Australian Institute of Architects

30 March 2020

To: Department of Planning, Industry and Environment (DPIE) / Reference Western Harbour Tunnel & Warringah Freeway Upgrade EIS Application Number SSI-8863

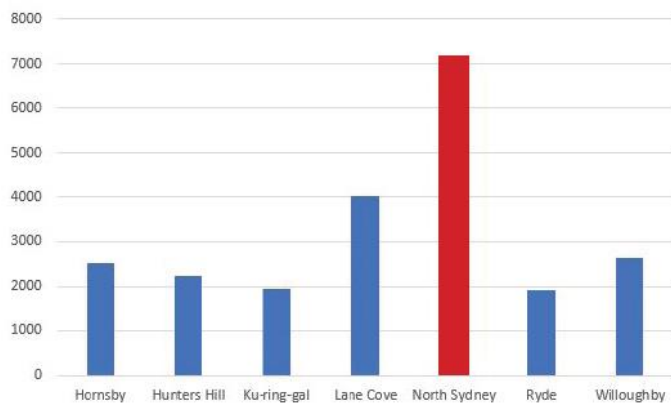
Problem: The tunnel extends from Rozelle to Cammeray and is 7.2km in length. Note also that the plan is that the emissions from the Beaches Link Tunnel (not part of this EIS) will also be discharged unfiltered from this same stack. Furthermore, the additional surface traffic adds to the pollution load. Concerningly, the exhaust stacks at Cammeray are less than 200m from the new ANZAC Park Public School.

Result: The quality of the air in Rozelle and North Sydney will be degraded by the emission of pollutants such as carbon monoxide, nitrogen dioxide, hydrocarbon residues and fine particulates. The preservation of good air quality is fundamental and vital to the health of the community. The health of and Rozelle and North Sydney will be adversely impacted by this proposal because of the design of the in tunnel ventilation system and the location of the emission stacks.

| The proposal should examine what opportunities exist to improve the situation if the were to adopt this position. The objective should be to ensure that pollution should be no worse than would be the case without this project. |
| As <i>Conditions of Approval</i> , we recommend: <ol style="list-style-type: none">1. The installation of transverse ventilation during construction – tunnels in Madrid, Tokyo and Stockholm offer strong precedents.2. Alternately install filtration technology in the stacks, compliant with International Best Practice. The recently completed Central-Wanchai bypass tunnel in Hong Kong is a precedent.3. That diesel heavy vehicles be banned from using this tunnel, as is the case for other tunnels over 4.5 kms in length (examples are the Paris Duplex Tunnel and Istanbul's Eurasia Tunnel). |
